Work Order ID 85312

Item Name: Float Skidtube Installation

Reference: RMA RA111368

From: David Shepherd <dshepherd@dartaero.com>
Sent: June-07-12 5:23 PM
To: 'Chris Provencal'
Cc: 'Mike Petsche'; 'Linda Lacelle'
Subject: RE: NCR D3391 mid tube

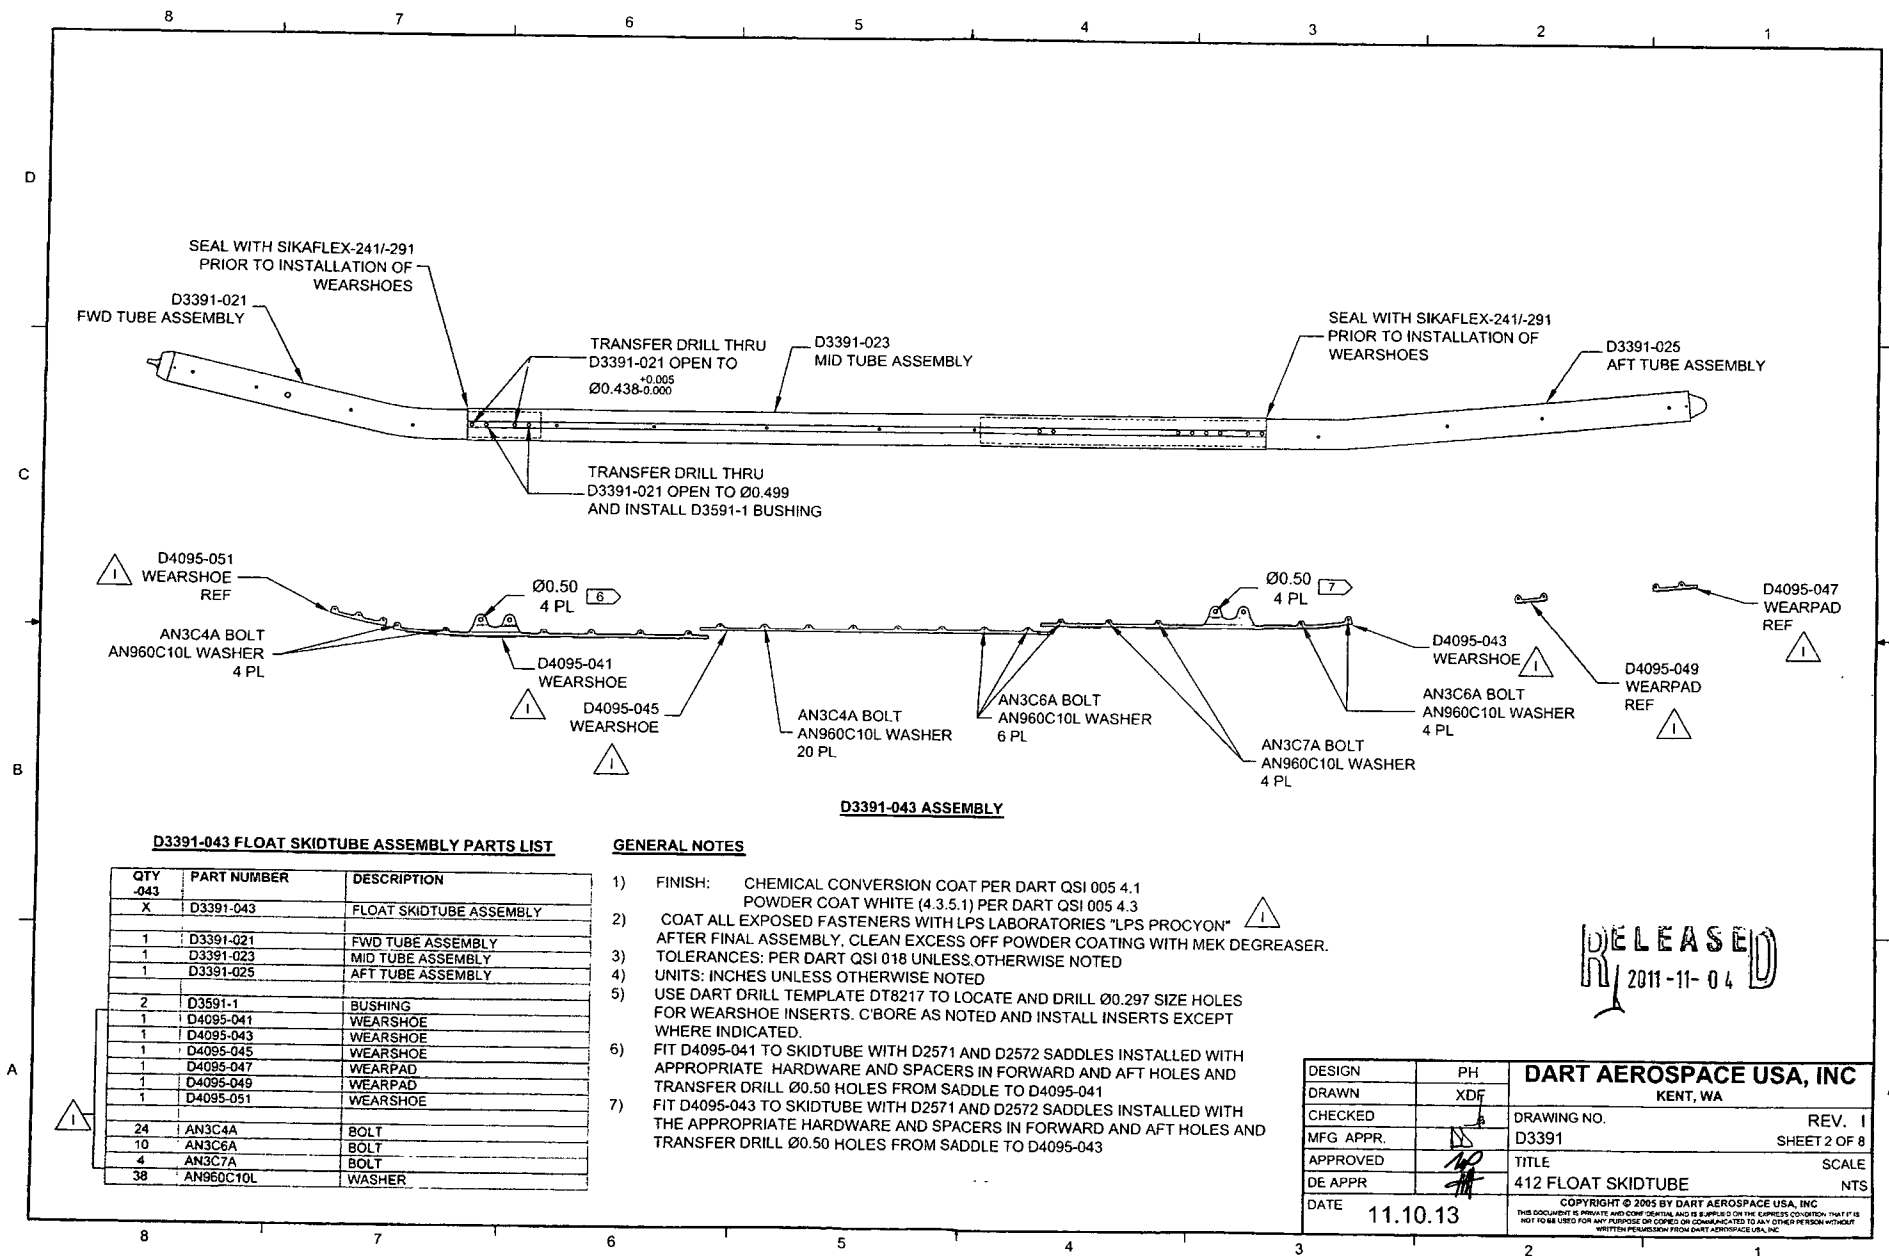
D3391-041 FLOAT SKIDTUBE ASSEMBLY PARTS LIST

| I | REMOVE GASKETS AND REPLACE ALL WEARSHOES; PARTS LIST UPDATE, ZN A8-1, ZN A8-2, ZN A6-4, ZN B6-8; LPS-3 COATING REMOVED FROM NOTE 2, ZN A3-1, ZN A3-2, REMOVED INSERT AELS-1032-130, ZN B6-4, B2-4, C7-8, C3-8; REMOVED HOLES, ZN D6-4 ZN D2-4, ZN D7-8, ZN D3-8 | XDF | 11.10.13 |
